**From:** Detterman, Mark, Env. Health  
**Sent:** Tuesday, August 16, 2016 9:47 AM  
**To:** 'Peter Langtry'  
**Subject:** RE: RO3226; VRAP Meeting Follow-up No. 2

## **914 West Grand Avenue Existing Ground Water Monitoring Well Scope of Work**

**Site Plan**  
**914 West Grand Avenue**  
**Residential Development**  
**Oakland, CA**

Figure Number  
Figure 2

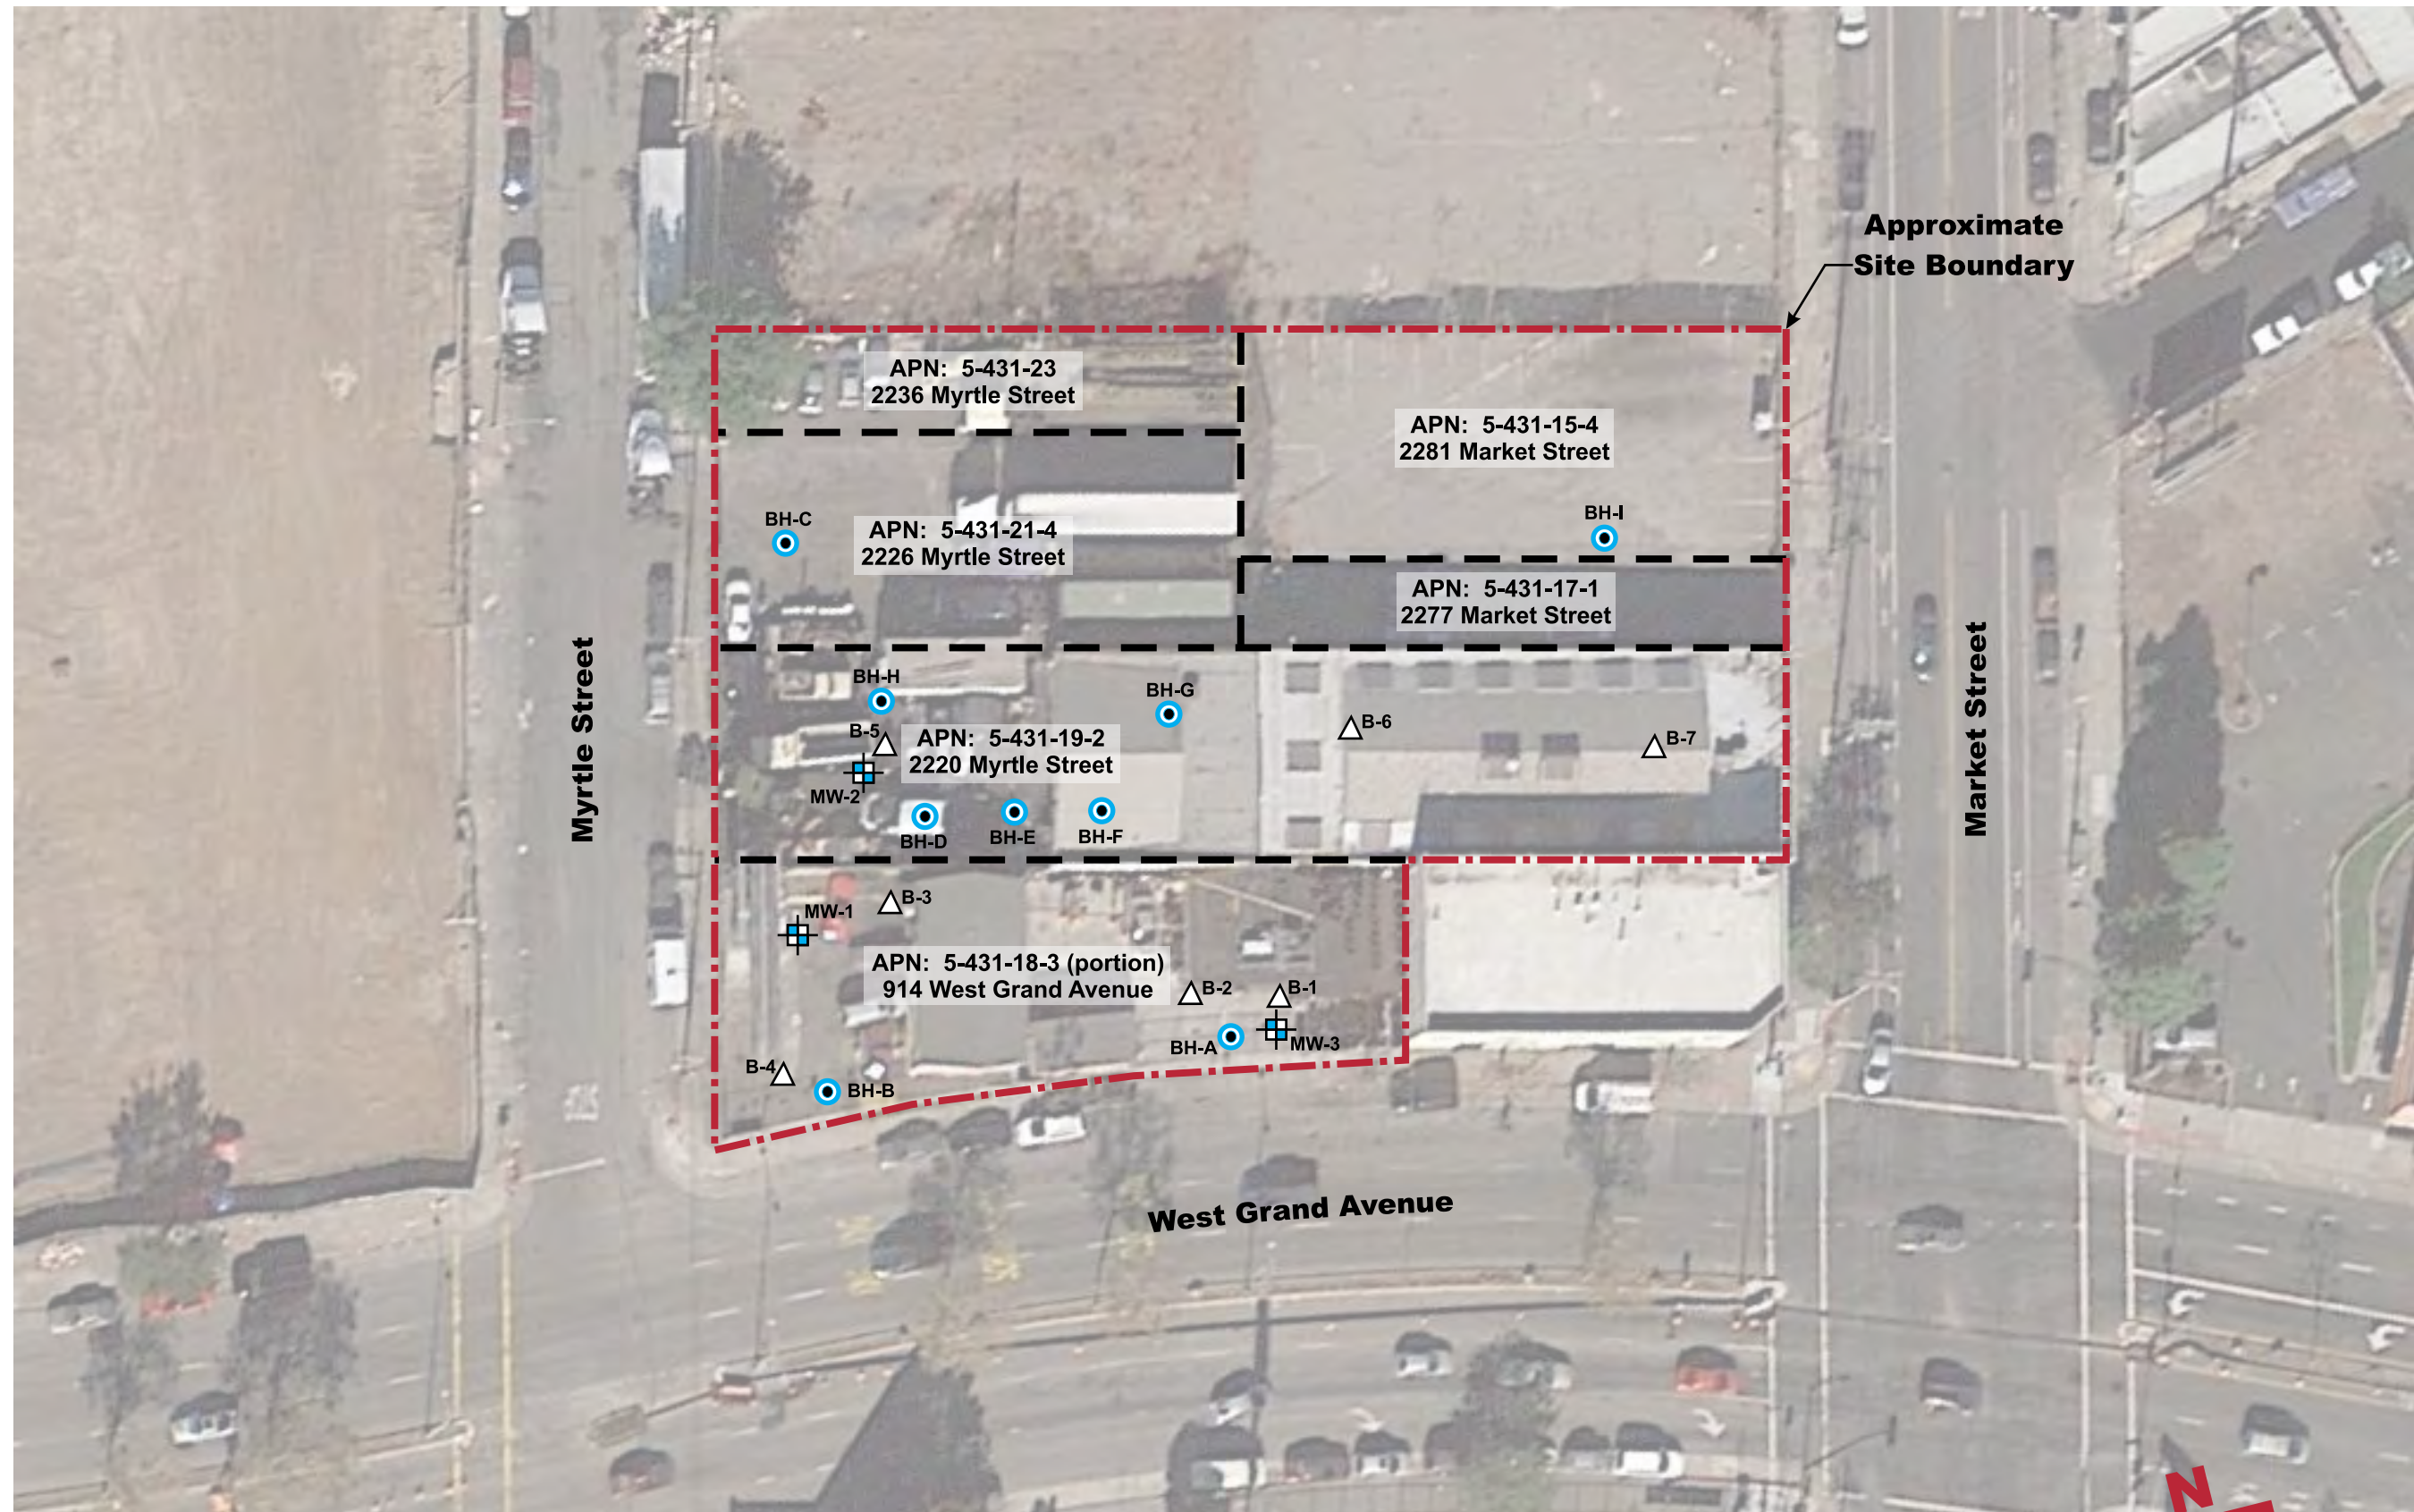
Thanks for the scope of work. My only input is to additionally request TPHmo due to the detects in the old ASE report, and then to request that extractable ranged hydrocarbons (TPHd and mo) be additionally run with and without SGC to stay within current RWQCB guidance to run both. Once we get an idea of relative ratios we can consider changing that in the future. I don't recall the last time the wells were sampled, but you might consider redeveloping the wells to ensure we're analyzing concentrations in groundwater rather than on sediment in the groundwater.
